# DEVELOPMENT APPLICATION ASSESSMENT REPORT

Application Number:	DA2021/0322
Responsible Officer:	Dean Pattalis
Land to be developed (Address):	Lot 121 DP 237862, 12 Howse Crescent CROMER NSW 2099
Proposed Development:	Alterations and additions to a dwelling house
Zoning:	Warringah LEP2011 - Land zoned R2 Low Density Residential
Development Permissible:	Yes
Existing Use Rights:	No
Consent Authority:	Northern Beaches Council
Land and Environment Court Action:	No
Owner:	Adam Teofilo Juanita Teofilo
Applicant:	JJ Drafting

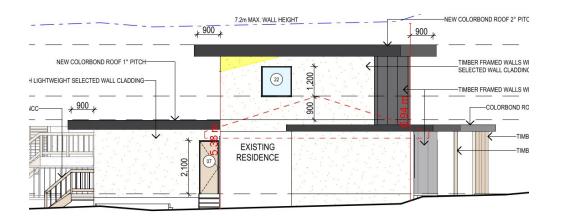
This control requires development to be sited within a building envelope - this is measured from the side boundary line to a maximum height of 4.0m, and then angled inwards at a 45 degrees. The proposed development is generally compliant with this control, except for a small portion of the first floor level along the western elevation, as indicated in the image below.
